<b>Product/Process Change Notice (PCN)</b>														
<input type="checkbox"/> Major Change <input checked="" type="checkbox"/> Minor Change														
<b>PCN Number:</b> PCN_FrqXTAL_20250221  <b>Affected Series:</b> WE-XTAL  <b>Affected Part Number:</b> 830003000, 830016178, 830102447901  <b>PCN Date:</b> 2024-11-21 (YYYY-MM-DD) <b>Effective Date:</b> 2025-02-21 (YYYY-MM-DD)	<b>Change Category:</b> <input type="checkbox"/> Equipment/Location <input checked="" type="checkbox"/> General Data <input type="checkbox"/> Material <input type="checkbox"/> Process <input type="checkbox"/> Product Design <input type="checkbox"/> Shipping/Packaging <input type="checkbox"/> Supplier <input type="checkbox"/> Software													
<b>Contact:</b> Product Management  <b>Phone:</b> +49 (0) 7942 - 945 5001  <b>Fax:</b> +49 (0) 7942 - 945 5179  <b>E-Mail:</b> pcn.eisos@we-online.com	<b>Datasheet Change:</b> <input checked="" type="checkbox"/> Yes <input type="checkbox"/> No  <b>Attachment:</b> <input type="checkbox"/> Yes <input checked="" type="checkbox"/> No

### 3. Correction of the Product Dimensions:

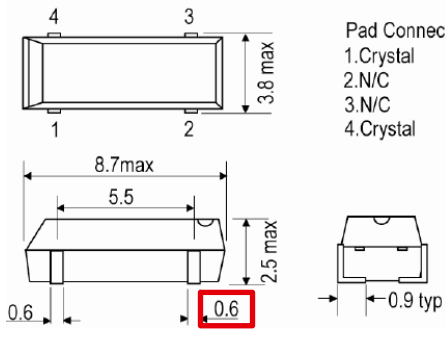
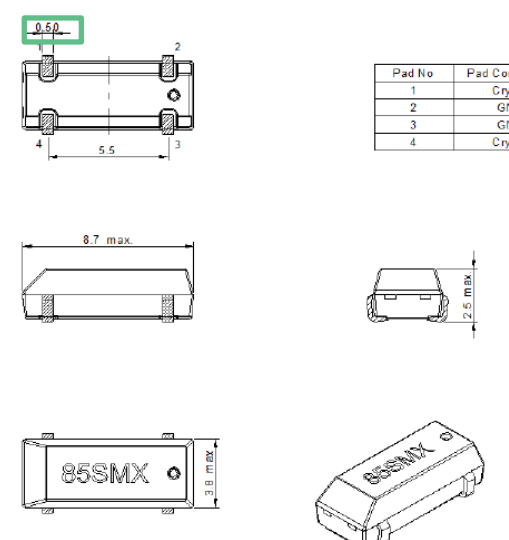
Before	After										
Product Dimensions	 <p>Pad Connection                      1. Crystal                      2. N/C                      3. N/C                      4. Crystal</p>

Pad No	Pad Connection	1	Crystal	2	GND	3	GND	4	Crystal
Pad No	Pad Connection											
1	Crystal											
2	GND											
3	GND											
4	Crystal

### 4. Correction of the Solder Pad Layout

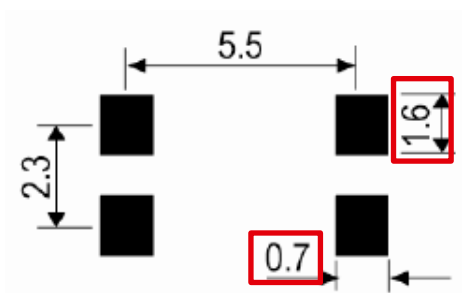
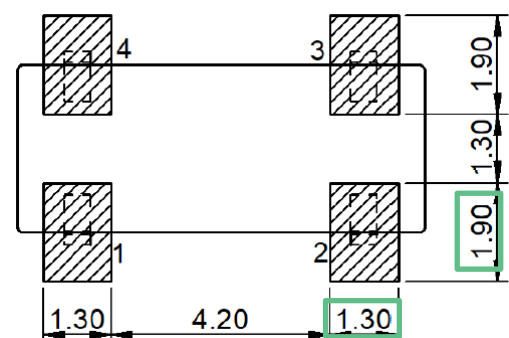
Before	After
Solder Pad Layout
